**CAPITAL CASCADE TRAIL CONSTRUCTION PLANS**

SHEET TITLE: E04.03r2

PROJECT NUMBER: BP20-006

**PARTIAL SITE PLAN**  
SCALE: 1/16"=1'-0"

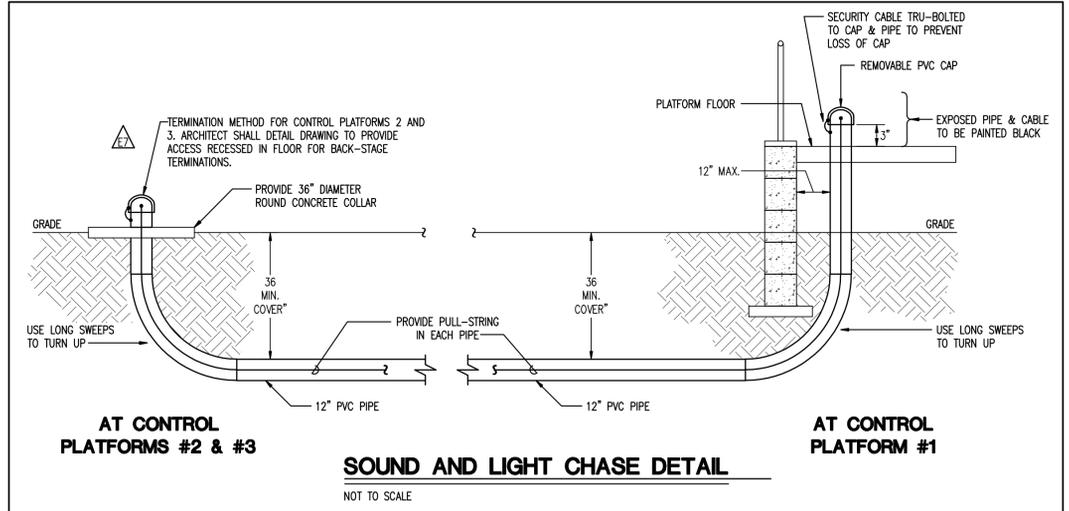
- ESI #E-11 WORK NOTES:**
- PROVIDE A HANDHOLE OF THE SIZE INDICATED WITH TOP FLUSH WITH SURROUNDING GRADE OR SIDEWALK SURFACE. HANDHOLE SHALL BE CLOSED-BOTTOM, CONCRETE POLYMER WITH A TIER-15 RATED COVER. DEPTH OF HOLE INDICATED IS MINIMUM. ADDITIONAL STACKED SECTIONS MAY BE REQUIRED DUE TO DEPTH OF CONDUIT. CORE-DRILL HOLES AS REQUIRED. PROVIDE QUARTZITE, NEW BASIS OR EQUAL. HANDHOLES ARE ILLUSTRATED HERE IN SCHEMATIC AND APPROXIMATE LOCATION. COORDINATE EXACT LOCATION AND TOP ELEVATION WITH SITE CIVIL/SURVEY.

- LOWER SECTION OF HANDHOLE (AROUND CONDUIT) MAY BE CAST-IN-PLACE CONCRETE AT CONTRACTOR'S SELECTION. PROVIDE ENGINEER WITH SKETCH OF PROPOSED CONSTRUCTION FOR REVIEW AND APPROVAL PRIOR TO CONSTRUCTION.

- PROVIDE A PULL-STRING IN EACH SEGMENT OF PIPE.
- ESI #E-13 WORK NOTES:**
- PROVIDE (1) 3/4" WITH 1 #12, 1 #12 N & 1 #12 G THRU LIGHTING CONTACTOR TO PANEL AND CIRCUIT INDICATED.

- PROVIDE LIGHT FIXTURES (BETA-CALCO/GHIDINI #820-7510-AG-RH-663) MOUNTED ON FACE OF SEAT WALL WITH ELECTRICAL CONDUIT EXTENDED THRU WALL. COORDINATE ROUGH-IN ELECTRICAL WITH WALL CONSTRUCTION PER LIGHTING MANUFACTURER'S GUIDELINES. MOUNT FIXTURE WITH CENTERLINE AT 14" AFF. SEAL CONDUIT PENETRATIONS OF WALL TO PREVENT MOISTURE INTRUSION. (TYP.)

- PROVIDE (1) 3/4" WITH 1 #10, 1 #10 N & 1 #10 G TO PANEL AND CIRCUIT INDICATED. PROVIDE NEW 20A/1P CIRCUIT BREAKER IN EXISTING PANEL INDICATED.
  - PROVIDE TWO DUPLEX, WP, GFI, ELECTRICAL RECEPTACLES INSET IN BACK WALL OF VIDEO STATION WITH METAL, WEATHERPROOF-IN-USE COVERS. PAINT COVERS BLACK. PROVIDE ENGRAVED PERMANENTLY ATTACHED LABEL INDICATING "LIGHTING POWER ONLY" ON EXTERIOR OF EACH COVER. CENTERLINE OF RECEPTACLES SHALL BE 14" AFF. COORDINATE ROUGH-IN ELECTRICAL WITH WALL CONSTRUCTION.

- PROVIDE TWO DUPLEX, WP, GFI ELECTRICAL RECEPTACLES INSET IN BACK WALL OF VIDEO STATION WITH METAL, WEATHERPROOF-IN-USE COVERS. PAINT COVERS BLACK. PROVIDE ENGRAVED PERMANENTLY ATTACHED LABEL INDICATING "SOUND POWER ONLY" ON EXTERIOR OF EACH COVER. CENTERLINE OF RECEPTACLES SHALL BE 14" AFF. COORDINATE ROUGH-IN ELECTRICAL WITH WALL CONSTRUCTION.

- PROVIDE A NEMA 3R JUNCTION BOX AT PANELS "L2" AND "L3" SIZED TO HOUSE THE CONTACTORS, CONDUIT AND CONDUCTORS. PROVIDE TWO 30A/1P CONTACTORS IN EACH (ONE IN EACH IS SPARE) WITH A PHOTO CONTROL ON EACH. PROVIDE A NEW 20A/1P CIRCUIT BREAKER IN EACH PANEL ("L2" AND "L3") FOR CONTROL VOLTAGE. PROVIDE CONTROL WIRING AS INDICATED IN DETAIL ON SHEET E04.03.
